BELLANCA AIRCRAFT CORP.

SERVICE LETTER NO. 39 MARCH 8, 1967

SUBJECT: PILOT RUDDER PEDAL REPLACEMENT

193129 TRIM TAB ASSEMBLY

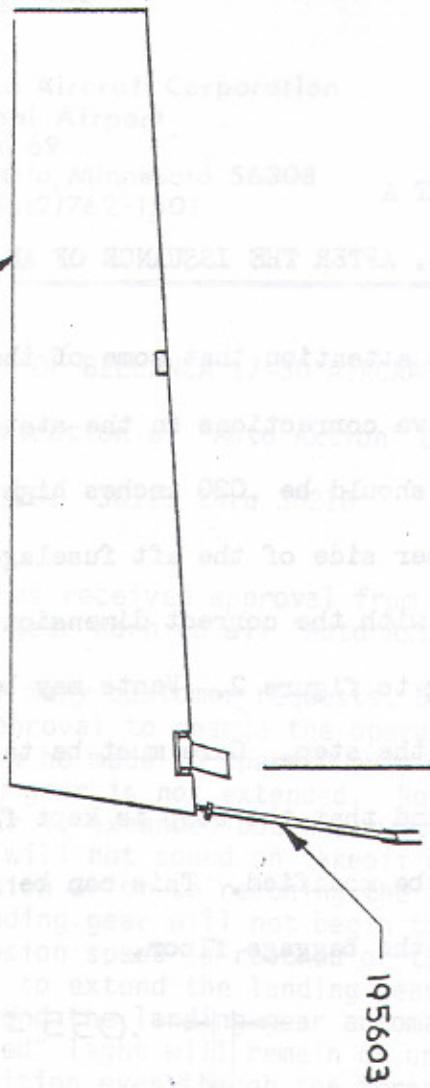
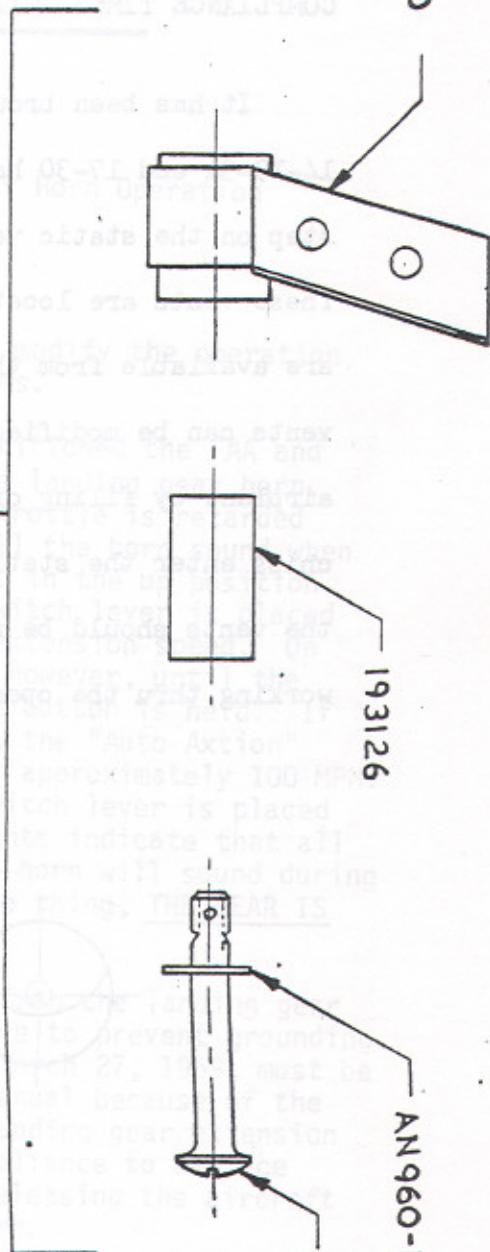
To install the new trim tab, remove the present tab and actuator rod. The access doors on the vertical tail at the elevator torque tube must be removed to allow the actuator rod to be disconnected from the actuator. The tab may be removed by removing the two AN bolts connecting bracket 195516-20 to the elevator (See fig. 1). To remove the pin engaging the center hinge, remove the shear pin at the inboard end of the tab hinge tube. To pull the pin, screw a coarse thread $\frac{1}{4}$ inch bolt into the hinge pin from the inboard end. This hinge pin does not need to move inboard more than $1\frac{1}{2}$ inches, and care must be taken not to damage the rudder by pulling the pin too far. With this pin removed, pull aft on the inboard end of the tab until the center hinge is free. Then slide the tab inboard to disengage the outboard hinge pin. Remove the 195516-20 hinge bracket from the tab as it will be used with the new tab. Save the present tab

Assemble the 195516-20 bracket to the new tab as shown in figure 1.

To adjust the travel of the new tab, block the elevator in the neutral position. That is, the chord line of the elevator and stabilizer should be in a straight line. With the trim control in the full "airplane nose down" configuration, adjust the rod end of the actuator rod until the trailing edge of the tab is $11/32$ " above the center line of the elevator trailing edge. This measurement must be made at the outboard end of the tab. Turning the tab control three turns, nose up, from full nose down, should cause the trailing edges of the tab and elevator to align. If a protractor or inclinometer is available to check the tab travel, it should be 4° up and 34.5° down, minimum from the aligned position. After tightening the jam nut on the rod end, be sure the rod end does not bind as the tab is moved through its full travel.

SCHEMATIC

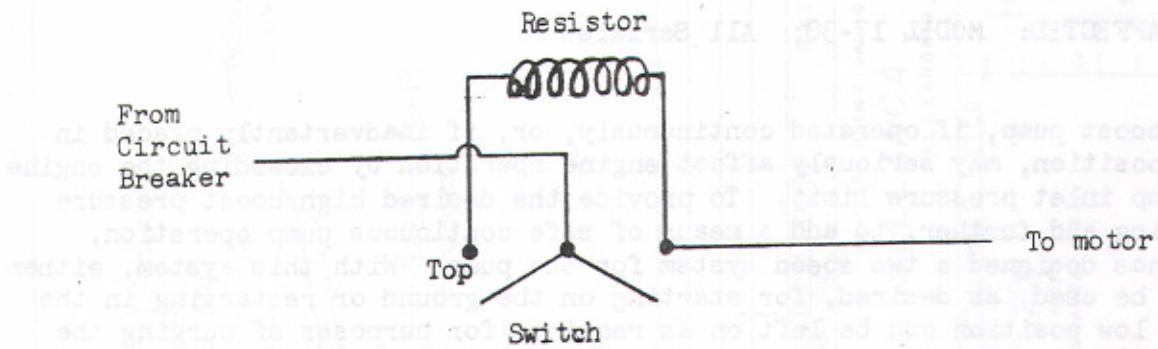
The fuel boost pump, if operated continuously, or, if inadvertently placed in the "ON" position, may seriously affect engine operation by exceeding the engine driven pump inlet pressure limit. To provide the desired high boost pressure for starting and further, to add a means of safe continuous pump operation, Bellanca has designed a two speed system for the pump. With this system, either speed can be used, as desired, for starting on the ground or restarting in the air. The low position can be left on as required for purposes of purging the system of vapor. Extended periods of continuous operation is not recommended.

In order to provide a means of operating the boost pump and not exceeding the engine pump limits, it is mandatory that this system be installed on the models affected. On or before the next annual inspection, install Bellanca Service Kit (SK2-1040) or its equivalent.

VIEW A-A

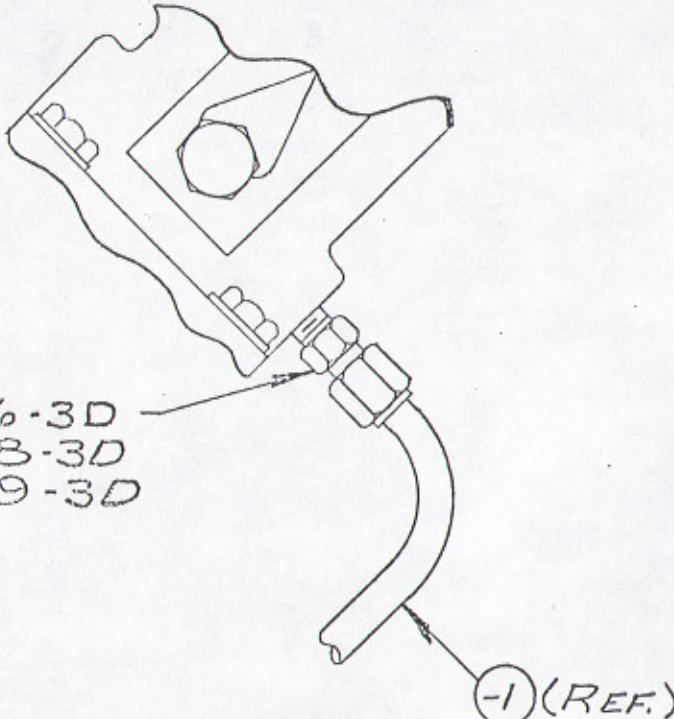
The Weldon brand fuel boost pump used on the affected aircraft will sometimes leak fuel into the electric drive motor when the pump seals become sufficiently worn. Drain ports are provided in the pump body which can be used to pass this leakage overboard.

It is recommended that the bottom port of this pump be plumbed to carry this fuel overboard. Hardware will consist of an AN fitting with a short piece of tubing from the pump to the exterior of the airplane. Since this hardware is readily available at modest cost, the factory will not offer kits. Drawing SK2-1037 is enclosed to owners of record of the affected aircraft. This drawing is available, on request, to dealers and repair stations.

WING INSPECTION &
DRAIN HOLE INST'L.

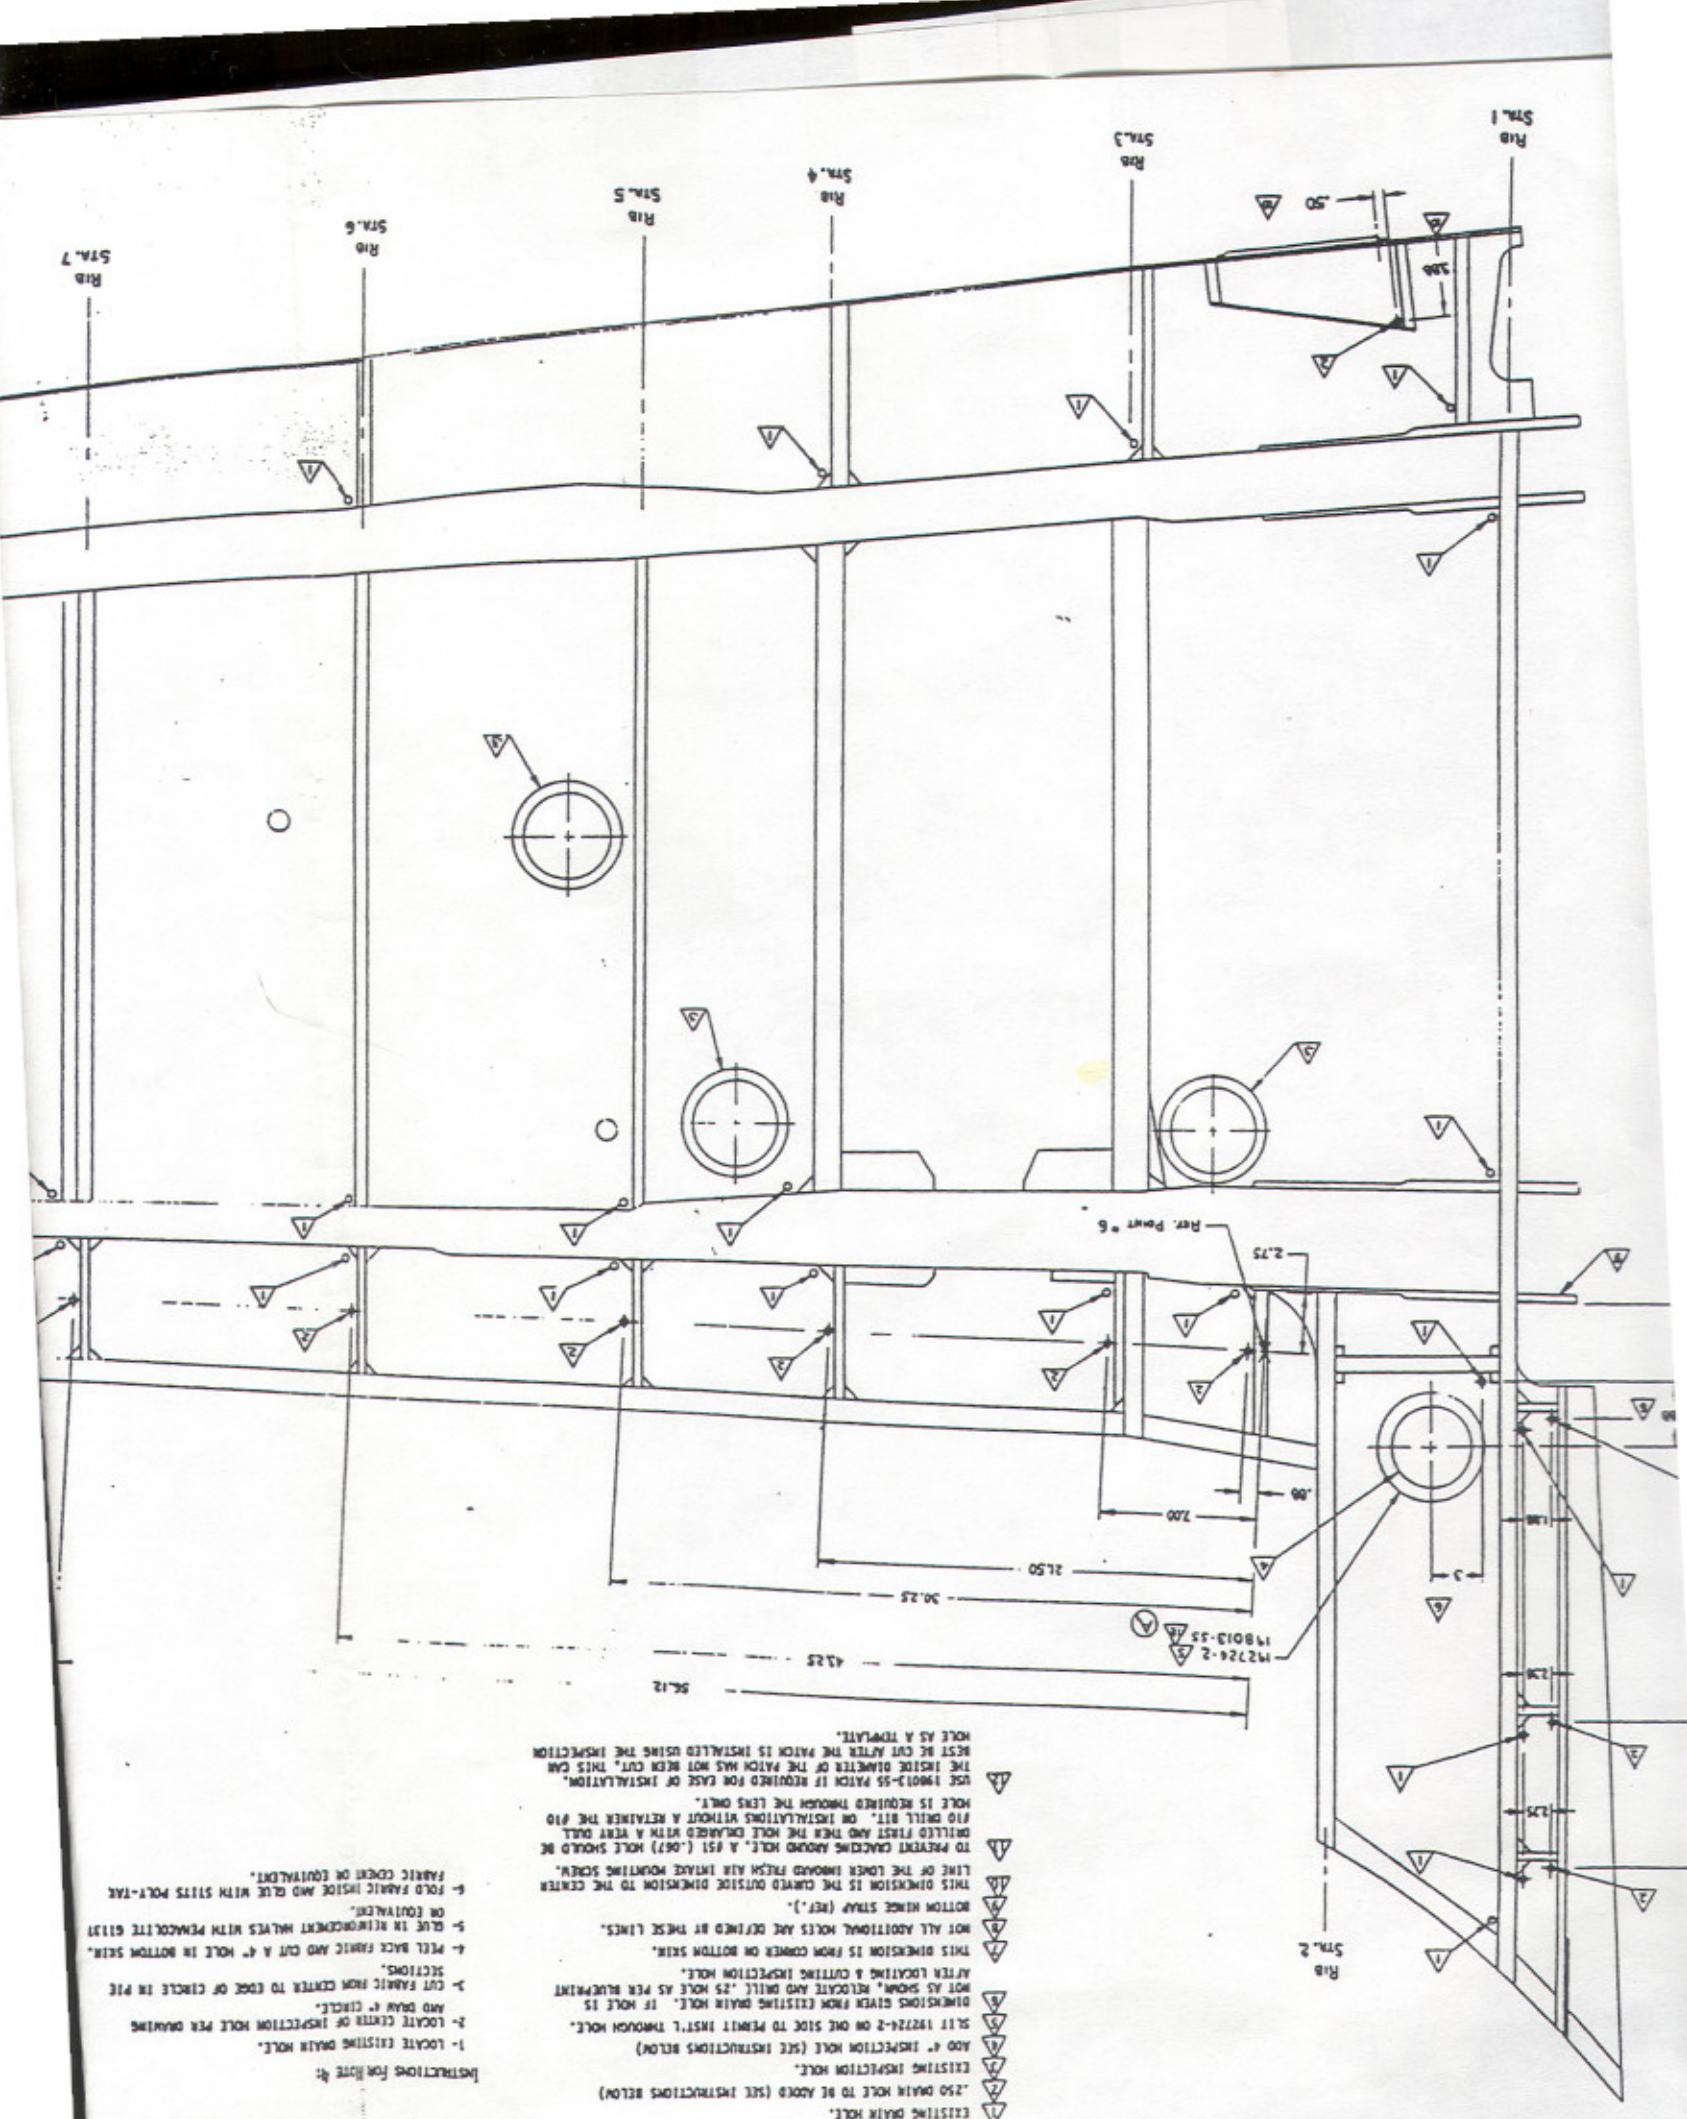
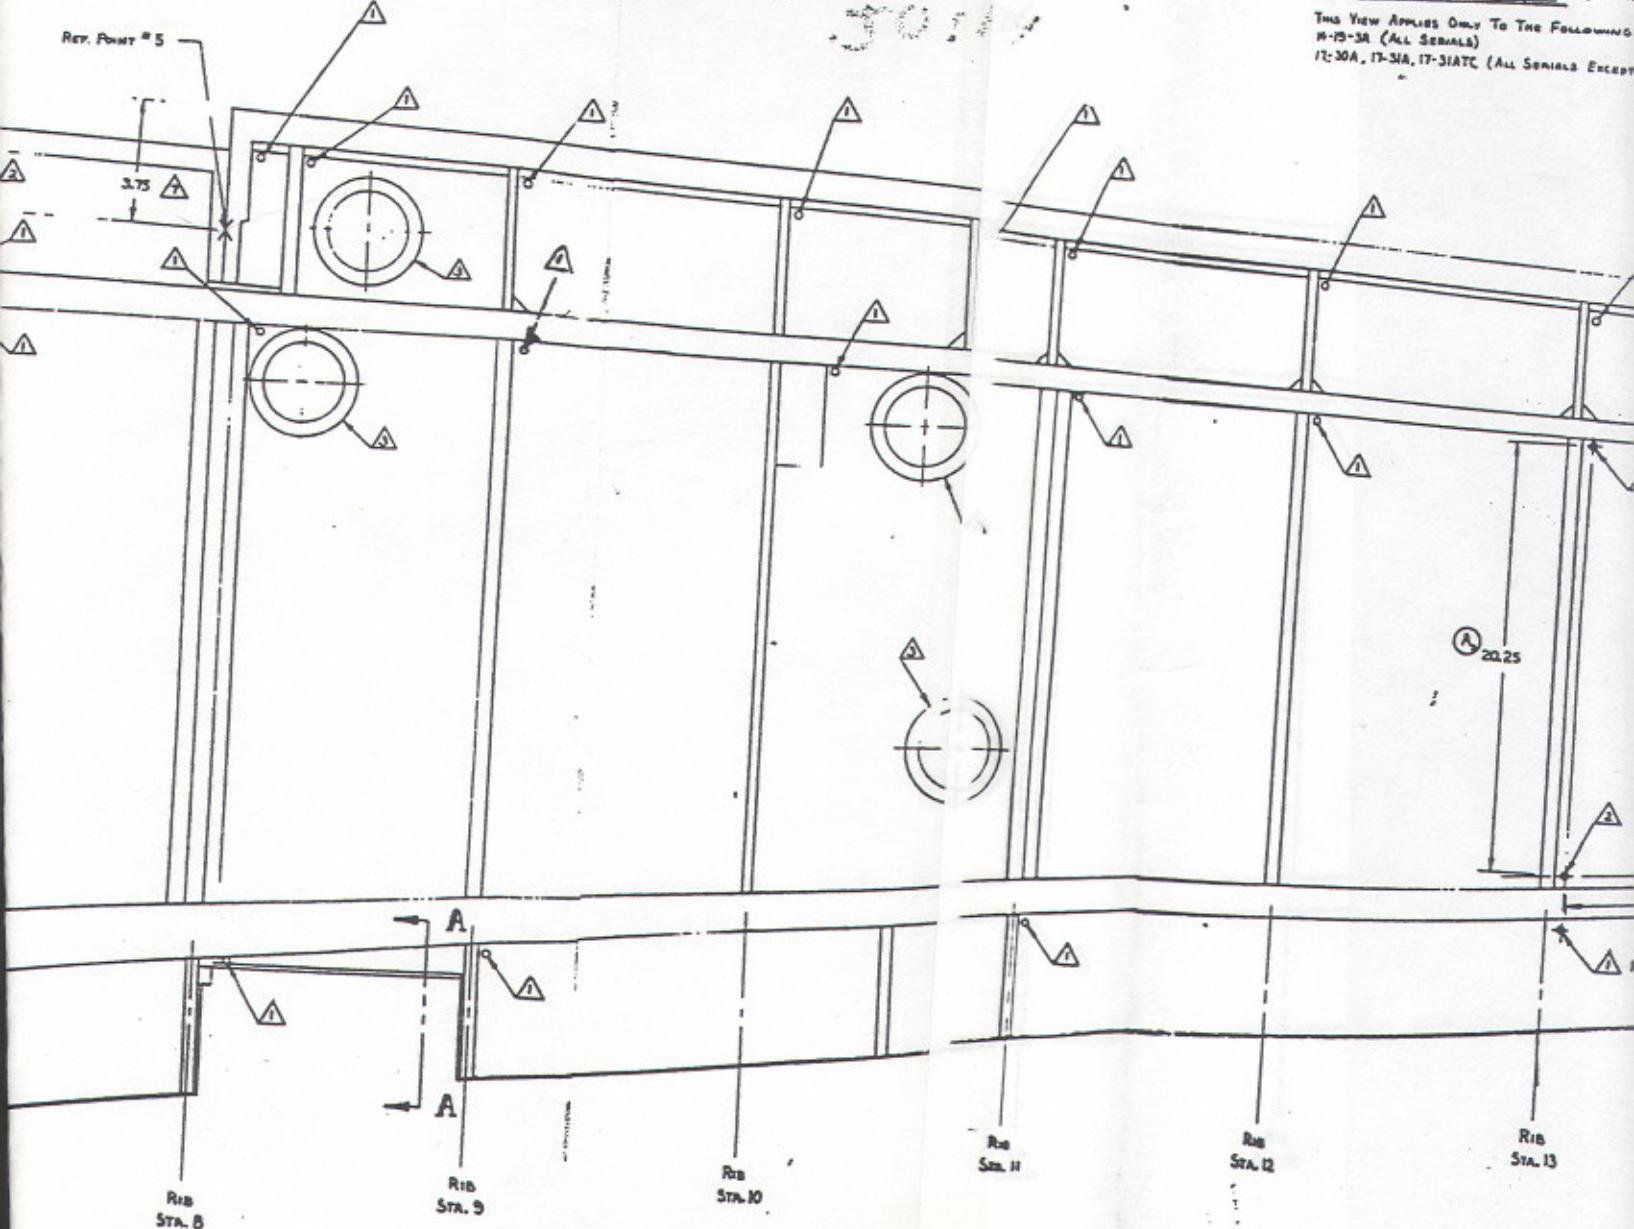
2- DRILL OUT PILOT HOLE WITH 1/4" DIAMETER DRILL BIT. REPOSITION HOLE IF NECESSARY TO ENSURE POSITIVE CLEARANCE FROM STRUCTURAL MEMBERS.

3- APPLY PLYWOOD WOOD SEALER AROUND EXPOSED EDGE OF HOLES.

VIEW OF TURBINE HOUSING WITH
TURBO CENTER SECTION REMOVED.

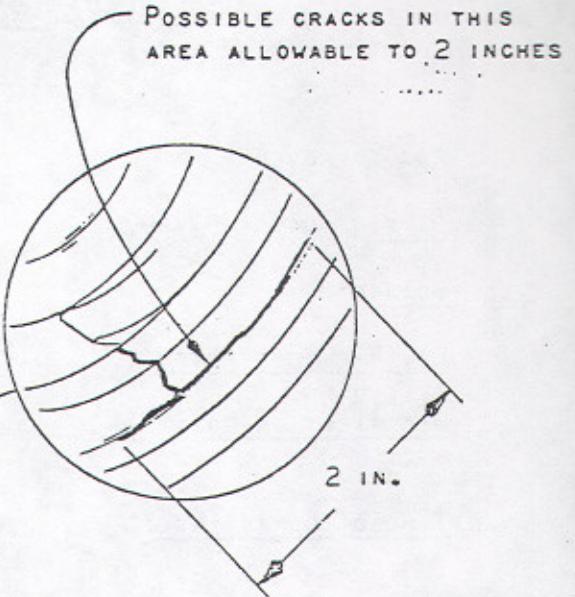
INSPECTION FOR HAIRLINE CRACKS IN THE TURBINE HOUSING INLET IN RAJAY TURBOCHARGER MODELS 301E10, 315F10, 325E10, AND 325EF10. THESE TURBOCHARGERS ARE FITTED WITH TURBINE HOUSING PART NUMBERS TC 59-11, TC 60-11, OR TC 82-11 AS APPLICABLE.

IT IS RECOMMENDED THAT THE INSPECTION SCHEDULE OF THIS LETTER BE PUT INTO EFFECT AND CONTINUED UNTIL THE UNIT IS REPLACED WITH PART NO. TC 59-11 "E" CHANGE OR LATER, TC 60-11 "D" CHANGE OR LATER, OR THE TC 82-11 "A" CHANGE OR LATER, APPROPRIATE TO THE TURBOCHARGER MODEL.

**FIGURE 1.****FIGURE 1A.**

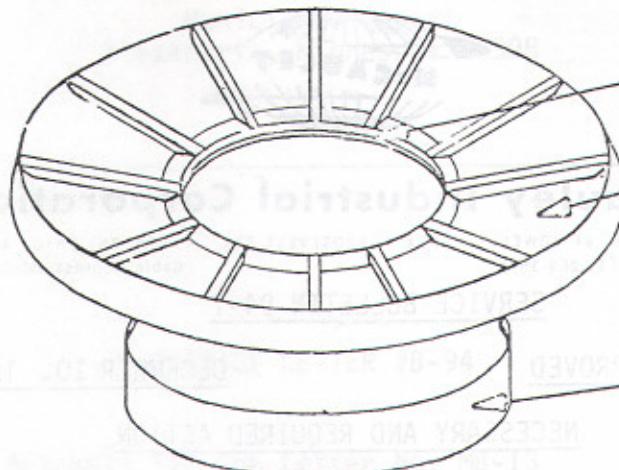
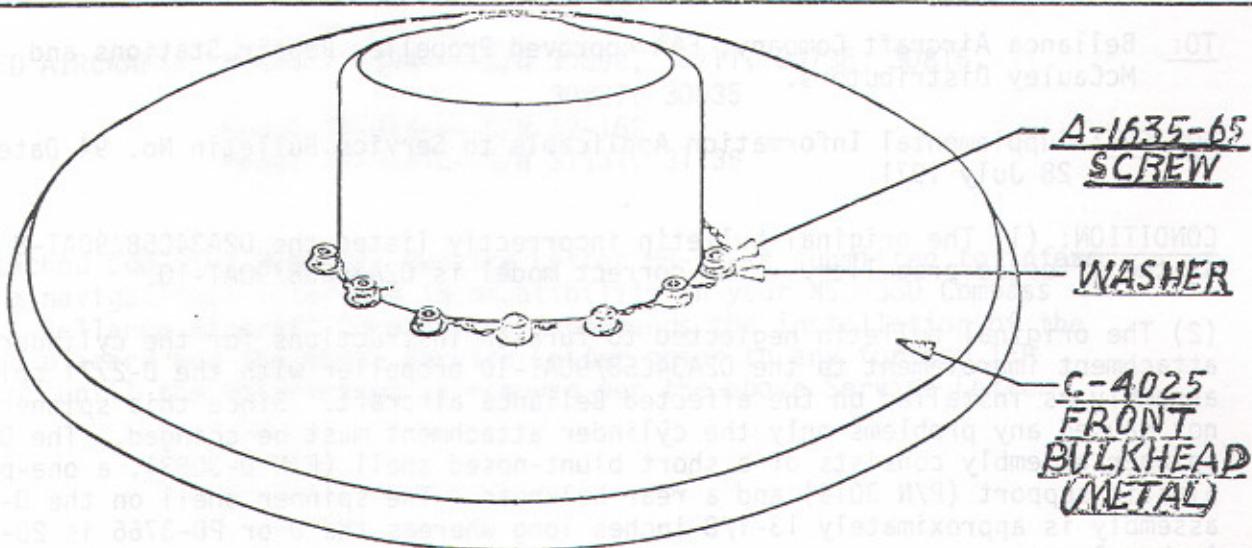
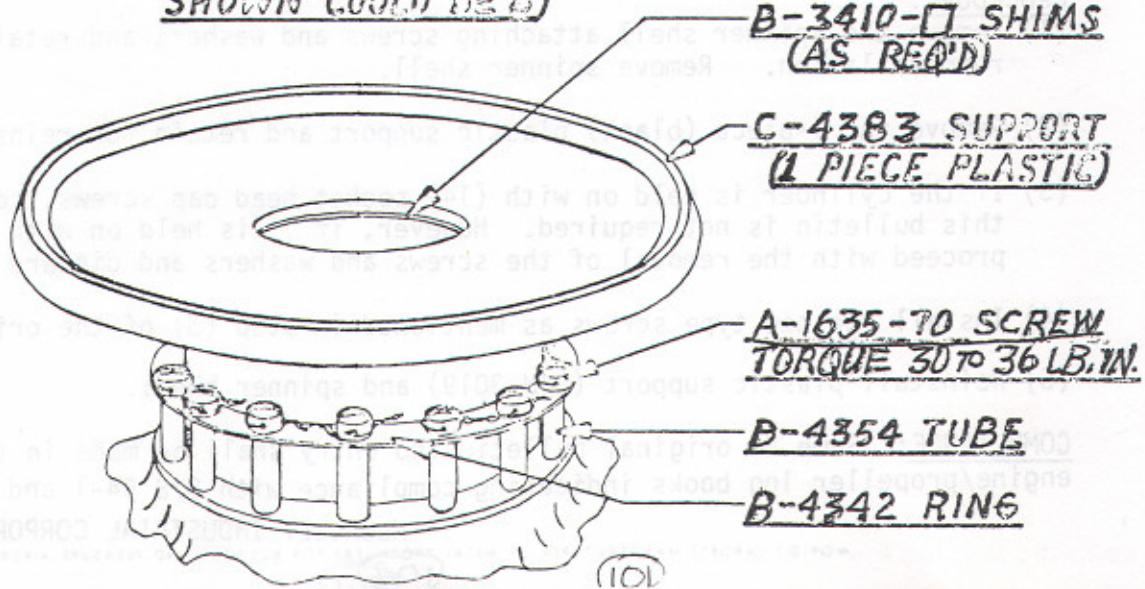
2. Remove the 8 or 14 screws and washers which attach cylinder and front spinner bulkhead to the propeller hub. Discard the metal front bulkhead (Fig. 1A) or the two-piece plastic support (Fig. 1), whichever is present, and all screws and washers. It is not necessary to remove the propeller cylinder.
